<input checked="" type="checkbox"/> ECO <input type="checkbox"/> ECR	NO. 4621	EFF DATE OF CHG 11 SEPT. 95	REQUESTED BY J. JONES	PREMIER	PAGE OF 1
REASON FOR CHANGE CONNECTOR INTERFERENCE		DOCUMENTS AFFECTED B32.23006	SYSTEM	MATL DISPOSITION	
MARKED PRINTS ATTACHED YES <input type="checkbox"/> NO <input checked="" type="checkbox"/>		EXTERNAL MOUNTING ARM DETAILS	SERIAL NO EFF	REWORK	STORE <input type="checkbox"/> IN MFG. <input type="checkbox"/>
				SCRAP	
				USE AS IS

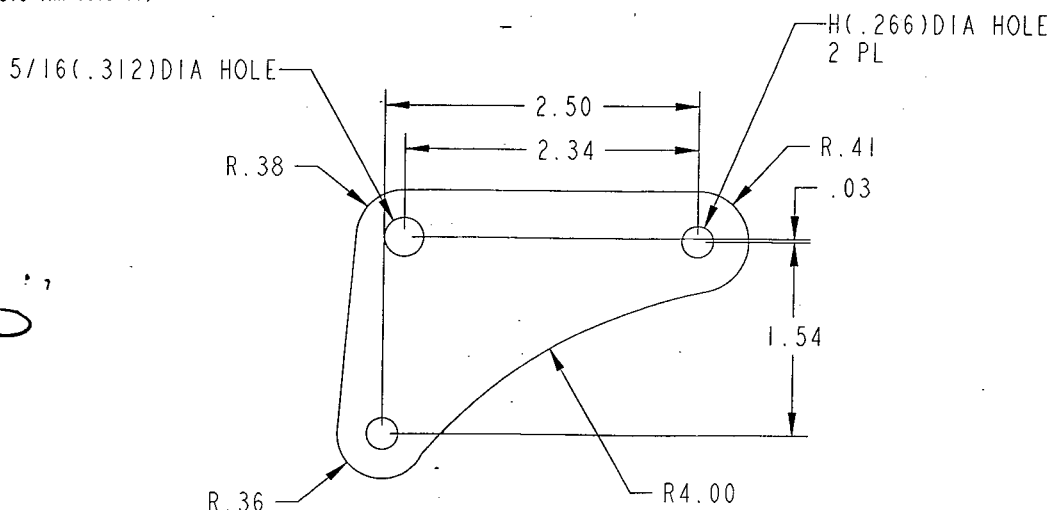
"Was"

-29 TAB
M/F: .375 THK 7075-T6, 00-A-250/12

"Is"
